Online Survey and Open House Summary Report

Trinity Bellwoods Park Access and Circulation Study

Phase 2: Exploring Recommendations

City of Toronto – Parks and Recreation

Figure 3. Site plan showing the proposed circulation and pathway hierarchy in Trinity Bellwoods Park.

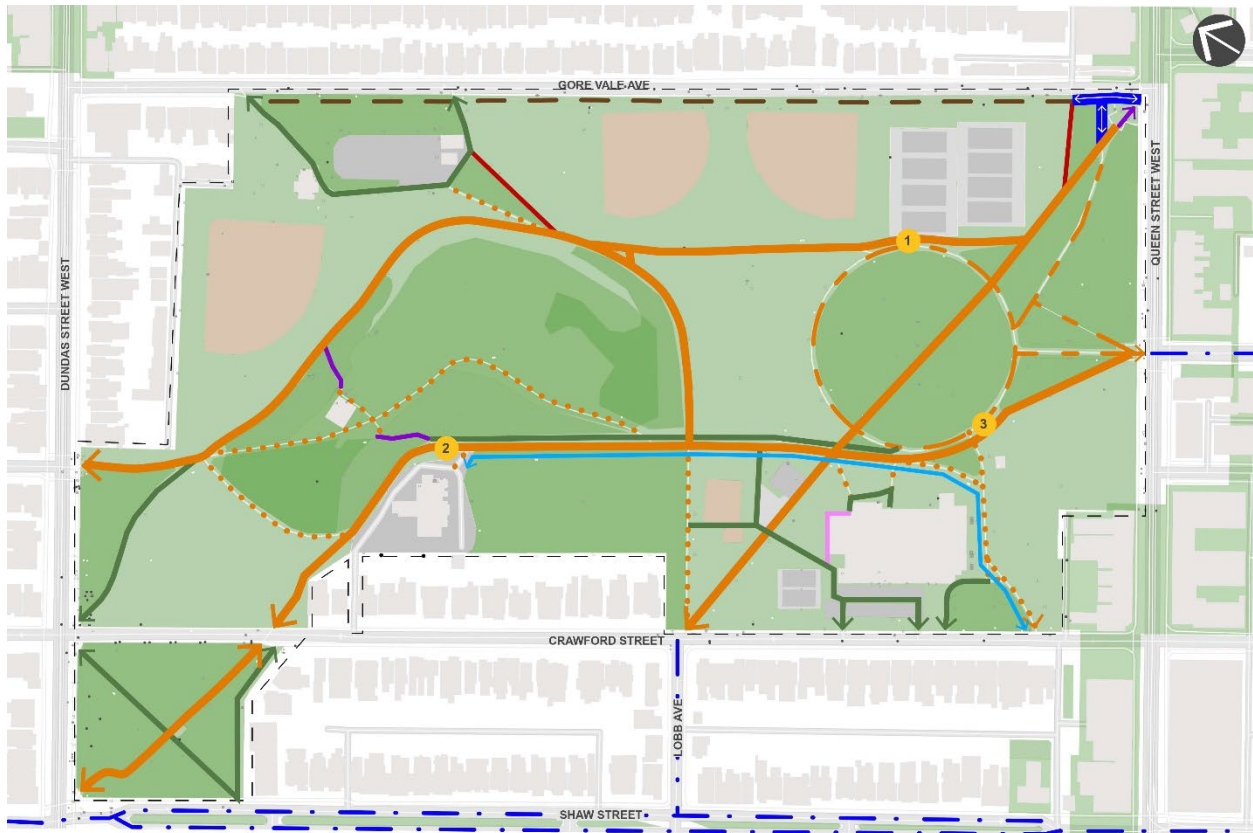
- 116 comments about conflicts between pathway uses: 65 comments requesting separate pedestrians and cycling paths, 30 comments expressing negative sentiments about cyclists, 18 comments requesting pedestrians be prioritized, 12 comments suggesting limiting or banning cycling and 11 comments requesting intervention to slow cyclists

- 26 comments about removing the inaccessible pathway connecting to Gore Vale Avenue north of Queen Street, with 25 comments requesting that the path remain

- 24 comments about pathway materials: 14 comments requesting more attractive or green materials
- 24 comments about widening pathways: 12 comments were positive and 12 comments were negative

- 20 comments about maintenance: 13 comments requesting snow removal from pathways
- 15 comments about mountable curbs: 14 comments were negative, with six concerned about limits to cyclists and six concerned with tripping or accessibility

- 13 comments about paving unpaved paths: 12 comments were positive
- 13 comments about signage and wayfinding: 11 comments requesting signage to reduce user group conflicts

Figure 4. Illustration of the proposed separation of pathways at the tennis courts by Trinity Circle in Trinity Bellwoods Park's southeast area.

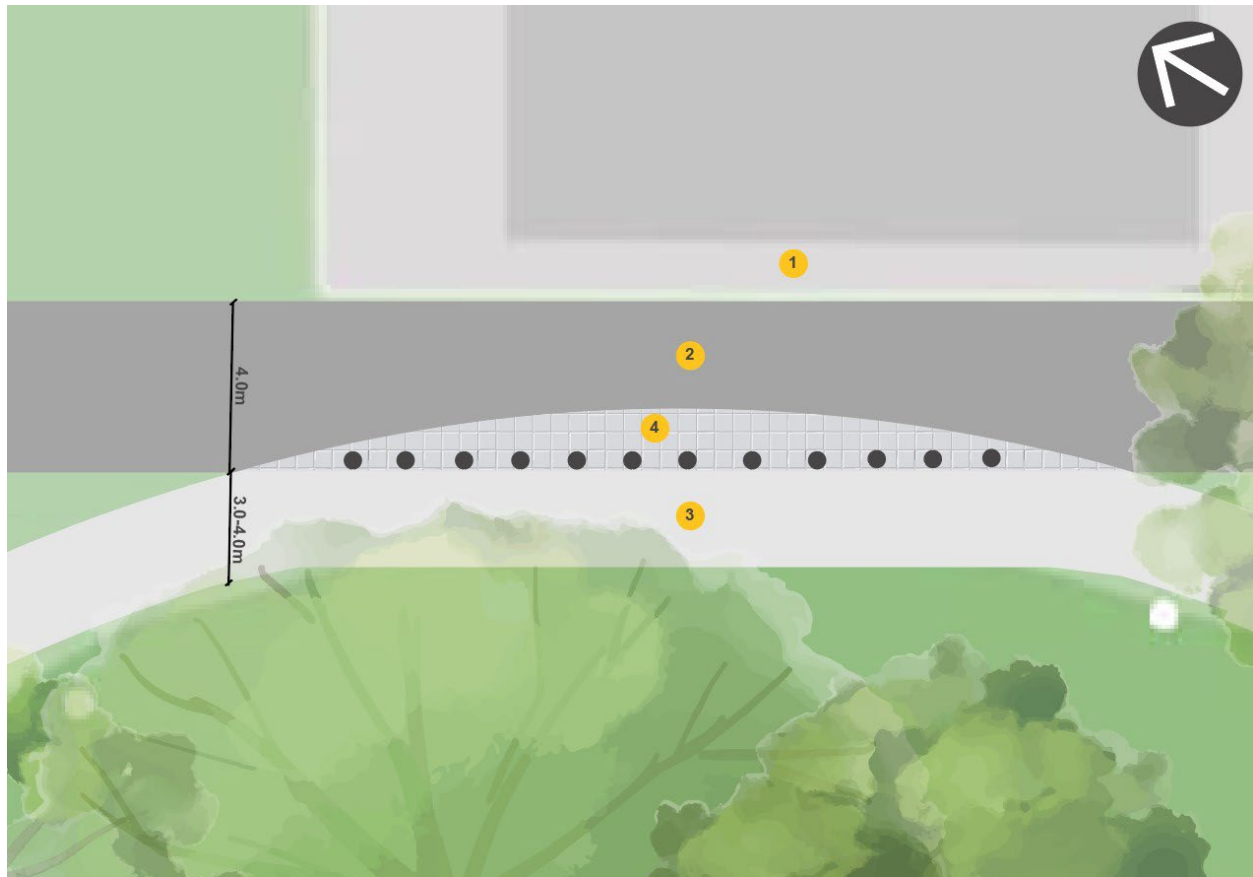
- 28 per cent of respondents strongly agreed with the recommendation, 42 per cent agreed, 13 per cent were neutral, nine per cent disagreed and four per cent strongly disagreed.
- Common themes in the comments and suggestions related to this recommendation included 34 negative comments about bollards and three comments concerned with the aesthetics of bollards.

- Three comments expressing concerns about bollards at the tennis courts and Trinity Circle hampering access for mobility devices and strollers

Figure 5. Illustration of the proposed primary route between the ravine slope and John Gibson House in Trinity Bellwoods Park.

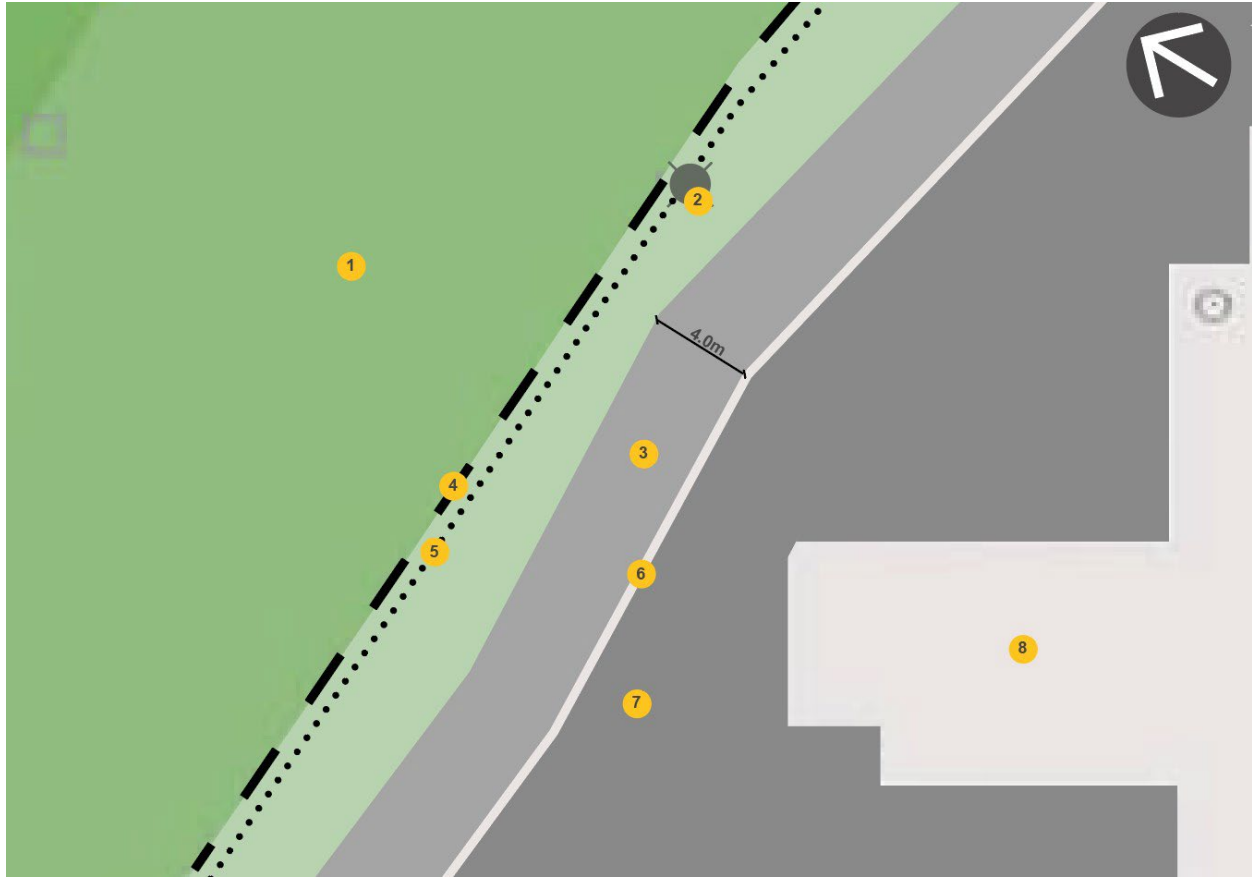
- 38 per cent of respondents strongly agreed with the recommendation, 39 per cent agreed, 11 per cent were neutral, five per cent disagreed and three per cent strongly disagreed.
- Common themes in the comments and suggestions related to this recommendation included 18 negative comments about the safety railings and eight comments noting the high volumes of pedestrians and cyclists on this path.

Figure 8. Illustration of the targeted recommendations for the Montrose Avenue at Dundas Street West entrance in Trinity Bellwoods Park's north.

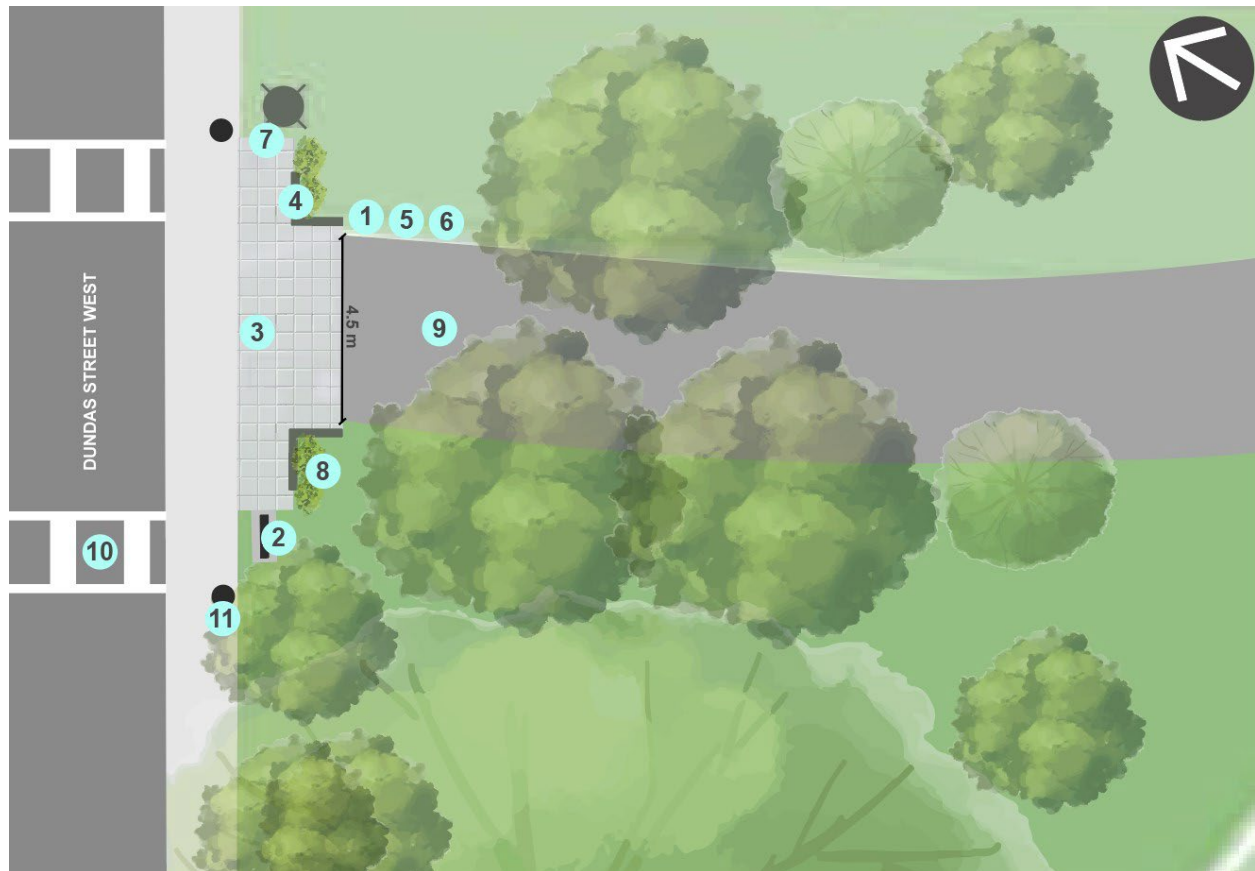
- 40 per cent of respondents strongly agreed with the recommendations, 37 per cent agreed, 11 per cent were neutral, four per cent disagreed and four per cent strongly disagreed.

Figure 10. Illustration of the targeted recommendations for the Strachan Avenue at Queen Street West entrance in Trinity Bellwoods Park's south.

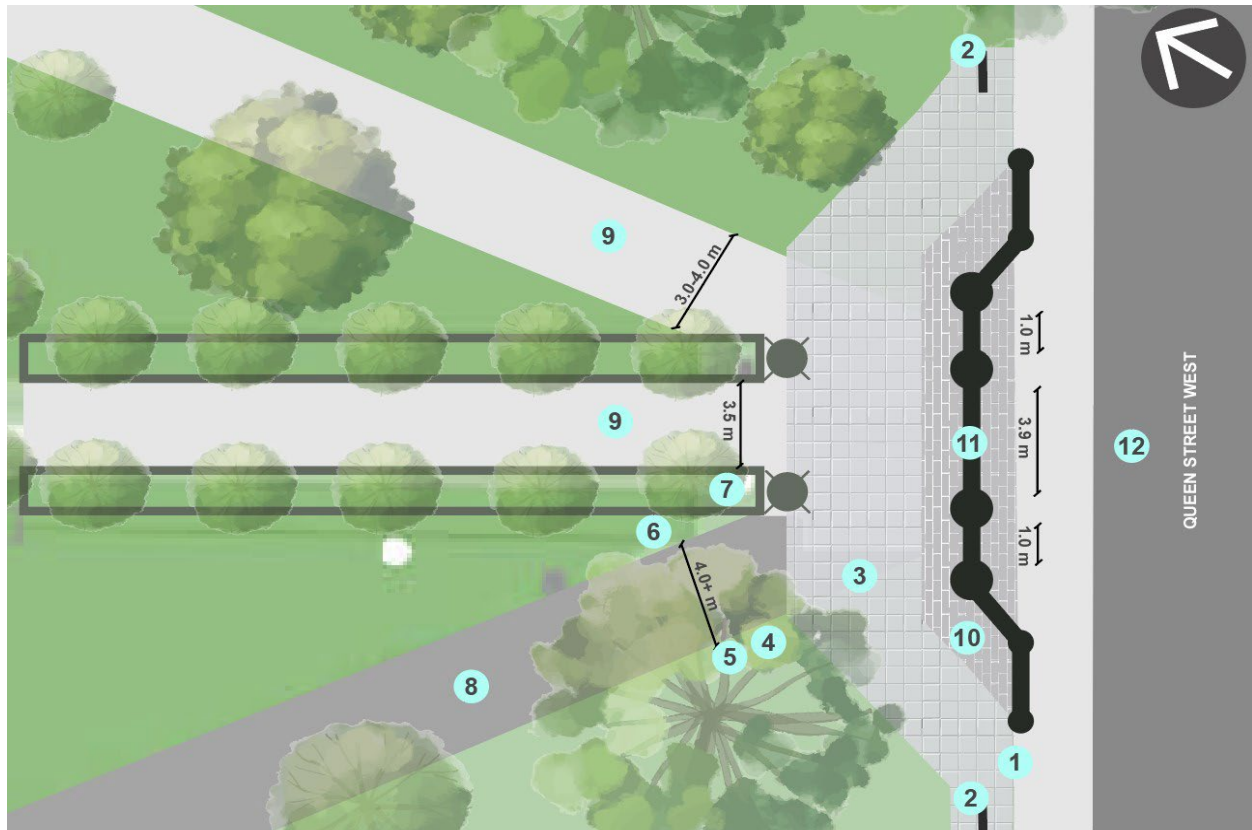
- 44 per cent of respondents strongly agreed with the recommendations, 33 per cent agreed, seven per cent were neutral, 11 per cent disagreed and four per cent strongly disagreed.
- Common themes in the comments and suggestions related to this recommendation included 10 comments requesting that the historic gates be preserved, four comments noting crowding or congestion, and four comments suggesting improvements to reduce user conflicts.

Figure 11. Illustration of the targeted recommendations for the Crawford Street crossing in Trinity Bellwoods Park's northwest quadrant.

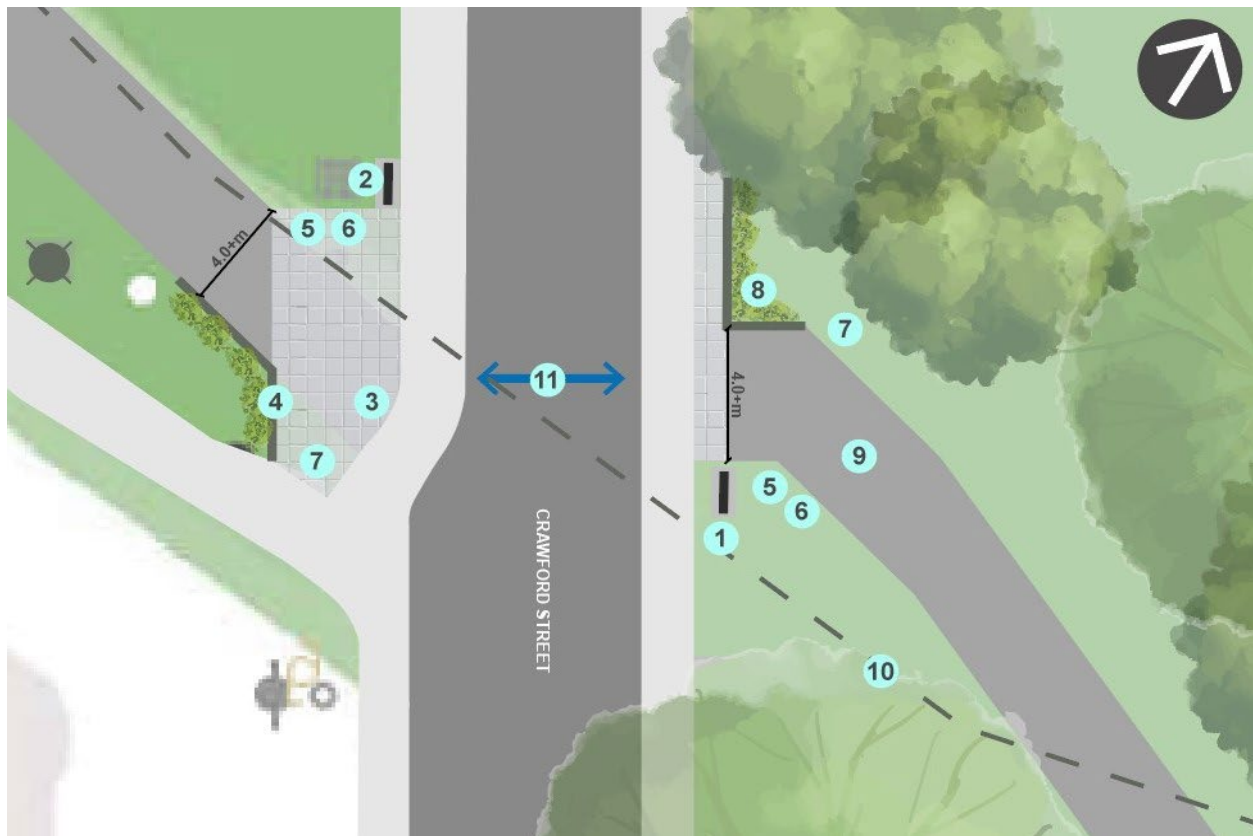
- 39 per cent of respondents strongly agreed with the recommendations, 37 per cent agreed, 11 per cent were neutral, seven per cent disagreed and three per cent strongly disagreed.
